Work Order ID 96731

Item Name: Crosstube Fwd

DRAWING NO. D407-667-145	TITLE CROSSTUBE ASS'Y (407 HIGH FWD)	REV. C	DART AEROSPACE LTD ENGINEERING ORDER		D.E.O. NO. D407-667-145-C-1	SHEET NO. SHEET 1 OF 1	SCALE NTS
DRAWN 9	CHECKED 155	MFG. APPR. 155	APPROVED WD		DE APPR. H		
DATE 11.07.15	DATE 11.07.22	DATE 11.07.22	DATE 11/07/22		DATE 11.07.21

DRAWING NO. D407-667-145	TITLE CROSSTUBE ASS'Y (407 HIGH FWD)	REV. C	DART AEROSPACE LTD ENGINEERING ORDER	D.E.O. NO. D407-667-145-C-2	SHEET NO. SHEET 1 OF 1	SCALE NTS
DRAWN AJS	CHECKED	MFG. APPR.	APPROVED	DE APPR.		
DATE 12.08.02	DATE 12.08.02	DATE 12.08.02	DATE 12.08.02	DATE 12.08.02	DATE 12.08.02

DETAIL P
BONDING STRAP INSTALLATION 2 PL

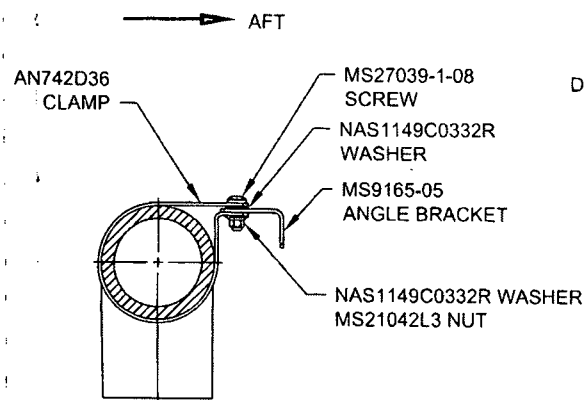
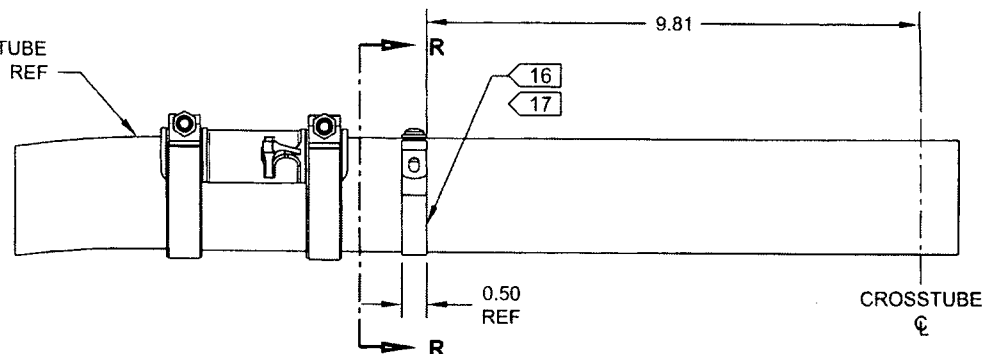
ADD ELECTRICAL GROUNDING STRAP

ITEM	QTY -145	PART NUMBER	DESCRIPTION
1	X	D407-667-145	CROSSTUBE ASSEMBLY (407 HIGH FWD)
10	2	AN742D36	CLAMP
11	2	MS9165-05	ANGLE BRACKET
12	2	MS21042L3	NUT (OR MS21042-3)
13	2	MS27039-1-08	SCREW
14	4	NAS1149C0332R	WASHER (OR AN960C10L)
